Air Quality Impact Modeling Protocol – Operations and Maintenance Emissions

Outer Continental Shelf Permit

Revolution Wind Farm

APPENDIX C : EPA PROTOCOL COMMENTS AND REVOLUTION WIND RESPONSE TO COMMENTS

Figure A-17
Overland Source and Receptor Grid

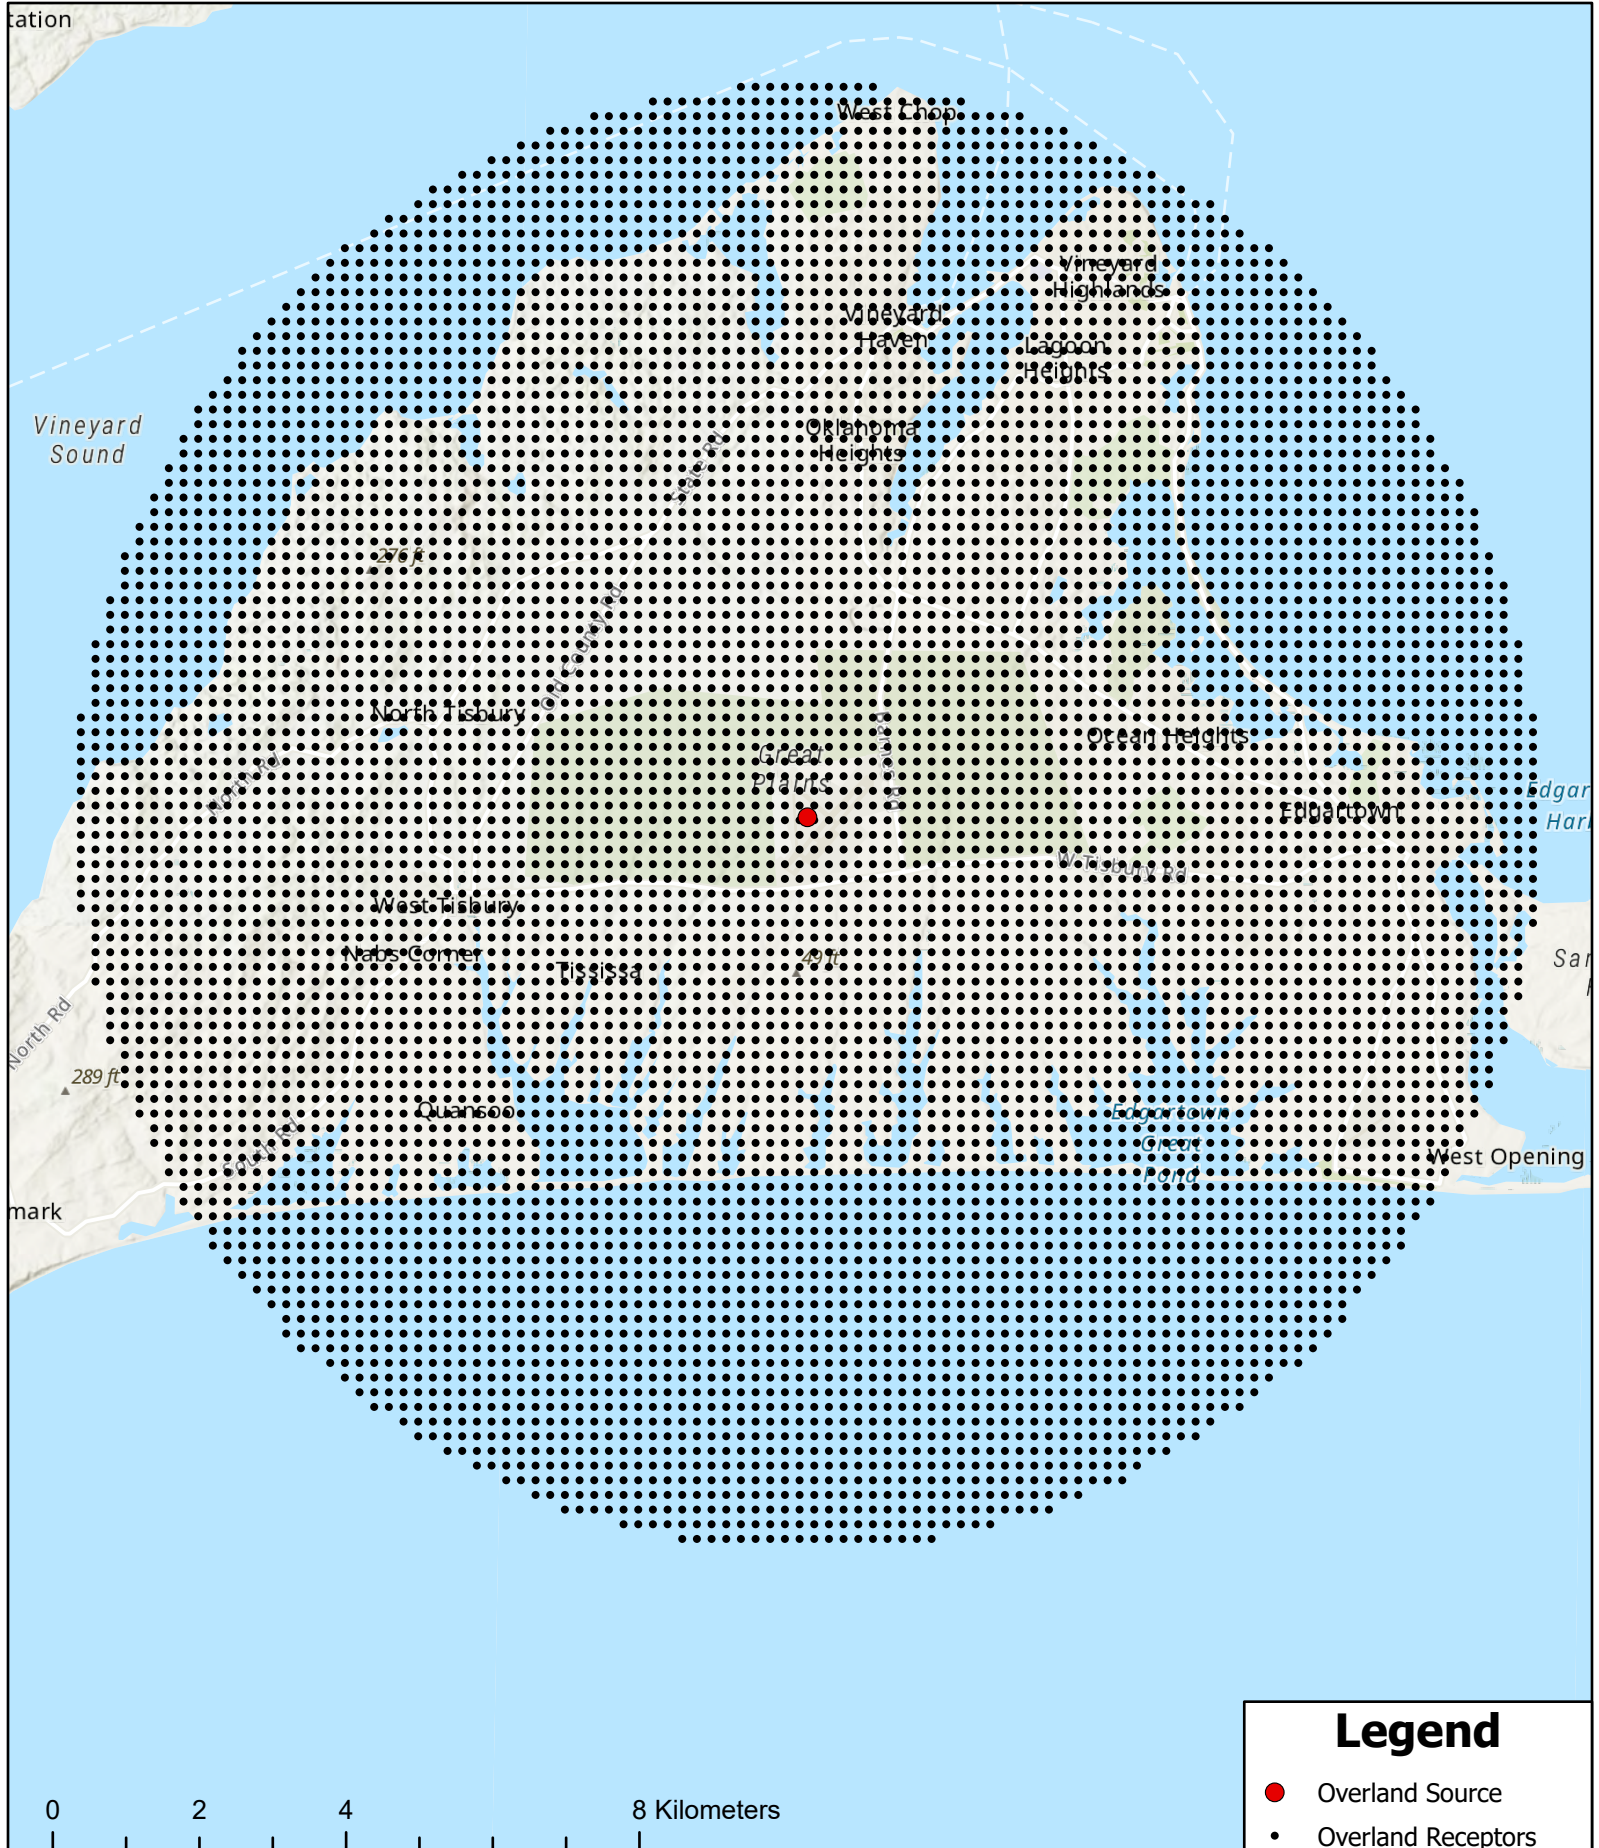
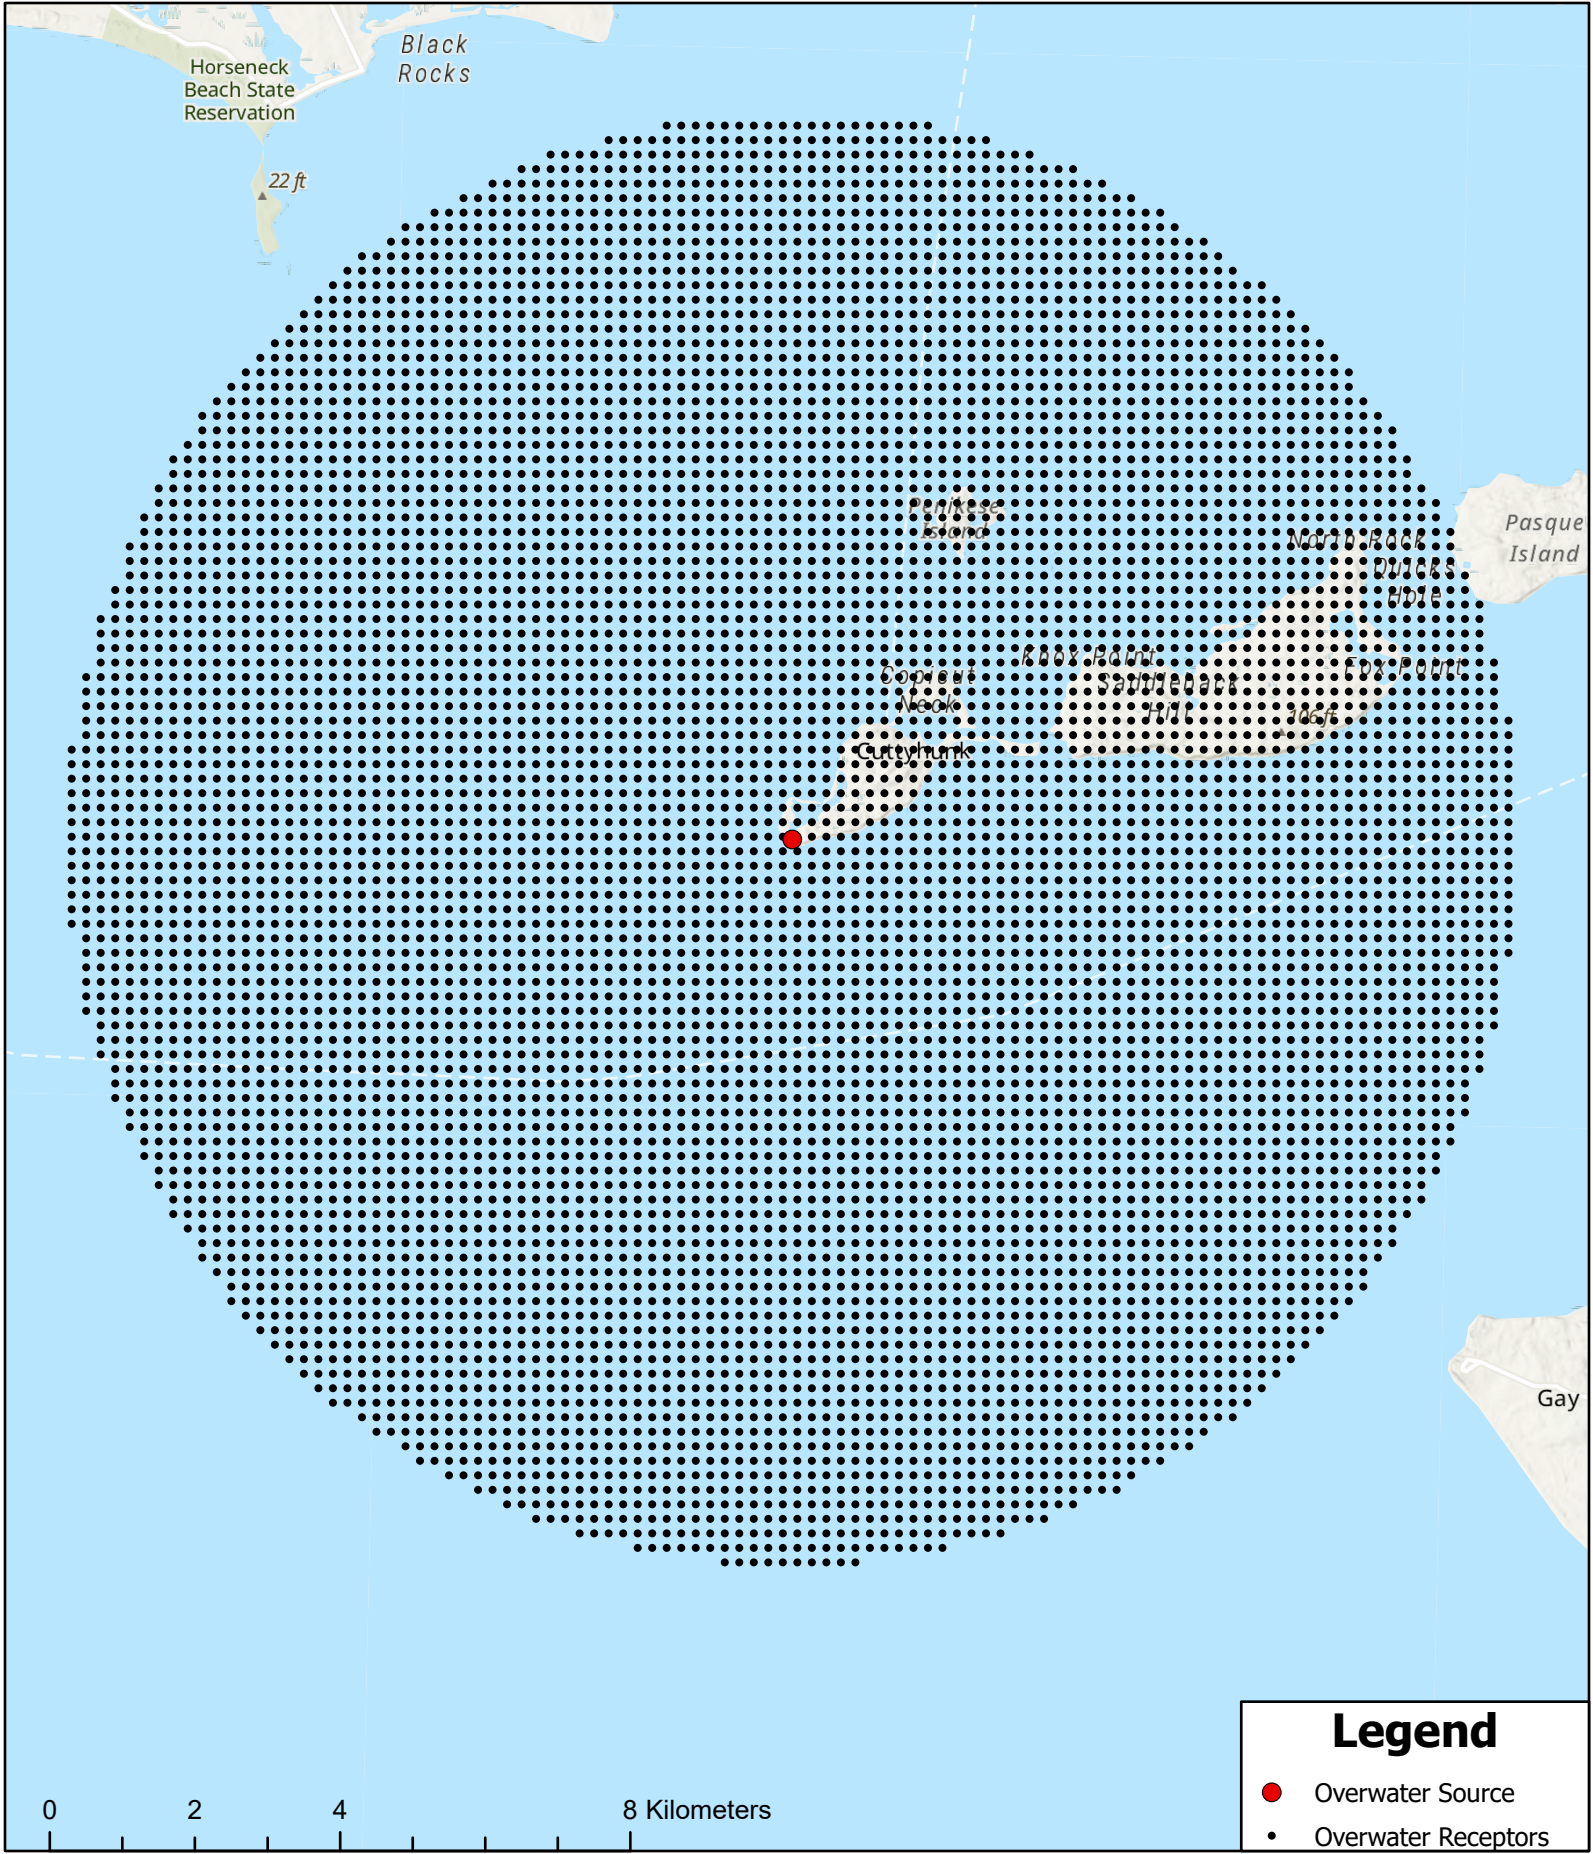
6. Even though several months of 2019 data were missing from the Buzzards Bay buoy, EPA recommends that available 2019 data be used in the comparative dispersion modeling analysis.
7. EPA recommends that a figure be included in Section A.3 to depict the locations of the single point sources modeled and the receptor grids used.

11. In response to comment #7 regarding the meteorological data evaluation, RW referenced Figures A-17 and A-18 in the revised Appendix A. However, the referenced figures were not included in the revised Appendix A. Please provided the referenced figures for EPA review.

11. *RW Response to Comment #7 Re: Meteorological Data Evaluation. In response to comment #7 regarding the meteorological data evaluation, RW referenced Figures A-17 and A-18 in the revised Appendix A. However, the referenced figures were not included in the revised Appendix A. Please provide the referenced figures for EPA review.*

Figures A-17 and A-18 in revised Appendix A depict the source and receptor locations used for the overland and overwater meteorological comparison modeling.
